ADDENDUM No. 6
LUC SR 2 21.72 NAVARRE SAFETY (PID 118234)

CITY OF OREGON
DEPARTMENT OF PUBLIC SERVICE

3) POWER SERVICE, AS PER PLAN - SERVICE ENCLOSURE SPECIFICATIONS

Title: K-SIZE UNOBSTRUCTED METER OUTLINE 32"W x 20"D x 60"H
Catalog No.:
Customer:
Drawing No.: K-Size STL Unobstructed
Date: 10-20-21 | Sheet: 1 of 1

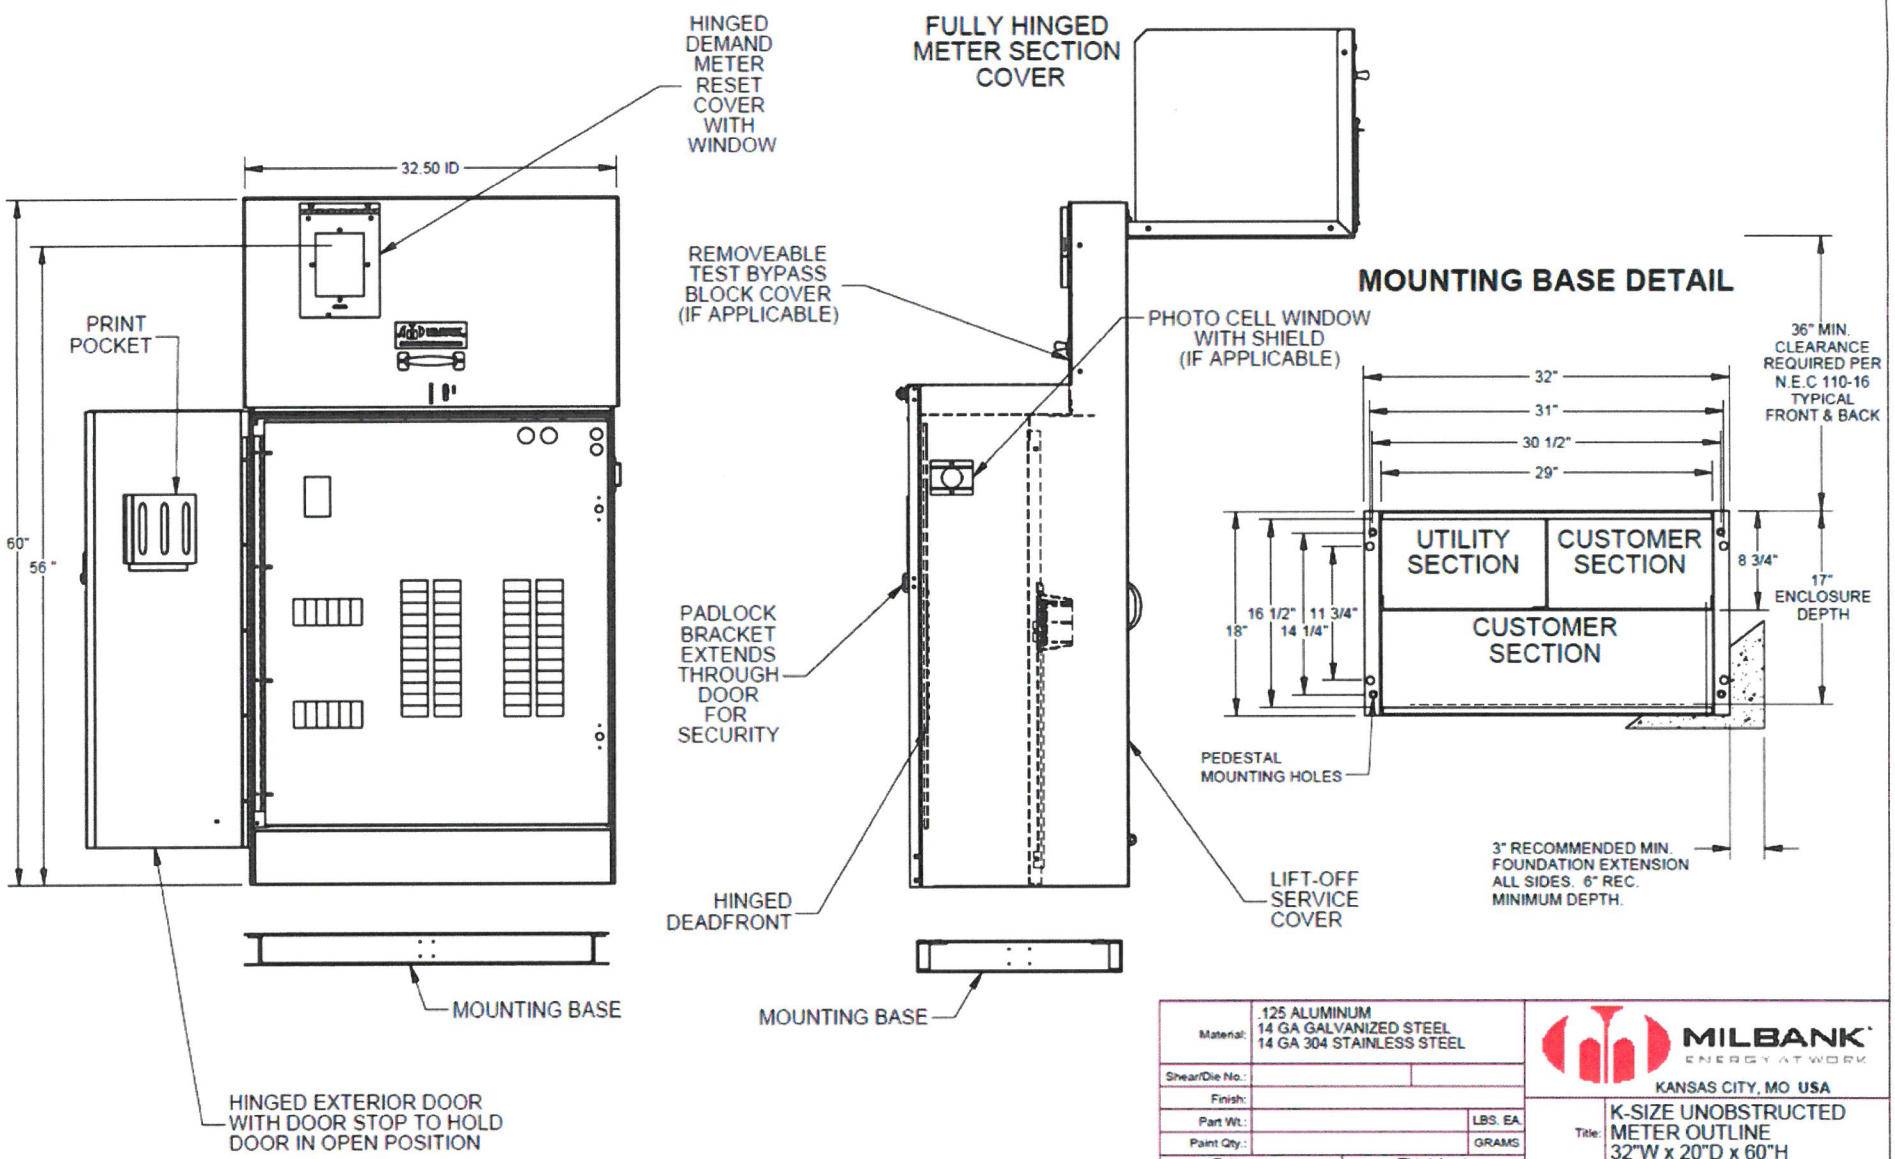
Please see the updated **Service Enclosure Specifications** for **Pay Ref 146 – ITEM 625 POWER SERVICE, AS PER PLAN, SIGNAL**, included with this addendum.

- Service enclosure shall be a commercial-grade, weather-resistant electrical pedestal that includes a utility pull section with a meter socket, along with a customer section housing distribution and control equipment.

- Service enclosure shall measure approximately 32.5” wide by 60” high by 17” deep, feature an internally mounted meter socket, and comply with EUSERC requirements.

- Service enclosure shall be fabricated from 14 gauge #304D stainless steel
- Interior of service enclosure shall be fabricated from 14-gauge cold rolled steel & painted white.

- Service enclosure shall be raw stainless steel.
- Service enclosure shall have continuous welded seams.
- Service enclosure shall have full-length deadfront with stainless steel hinge.

- Service enclosure shall be manufactured by Tesco, Milbanks or City approved equal.
